Access Compliance Report

Public Rights-of-Way

(Pedestrian Signals)

Intersection ID: N/A	Main Street:	Cross Street: N/A	Location: N/A
ADA ID: 061FE6D52BE4	Signal Type: Two Push Buttons-Non APS	Overall Compliance: No	Severity Score: BTN 1:N/A BTN 2: N/A No BTN: N/A
Codes/Mitigation Info/Possible Solution		Field Measurements/Component Compliance

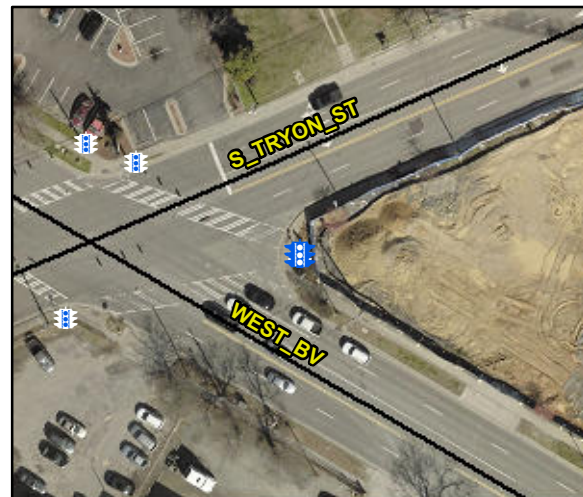
PROW/ADA: TMUTCD 4e.08, R404.1, R404.7.1, R404.7.2

Yes	B 1 Clear Xing Direction?	ClearlyMarked	Yes	B 2 Clear Xing Direction?	ClearlyMarked
	B 1 Crossing Direction	To NW		B 2 Crossing Direction	To SW
Yes	B 1 DistanceTo XWalk (in)	0.0	Yes	B 2 DistanceTo XWalk (in)	46.0
No	B 1 DistanceTo Curb (in)	127.0	No	B 2 DistanceTo Curb (in)	128.0
Yes	B 1 Diameter (in)	2.0	Yes	B 2 Diameter (in)	2.0

Possible Solutions: Replace Signal Push Button With APS Button on New Post. Remove & Relocate Sign.
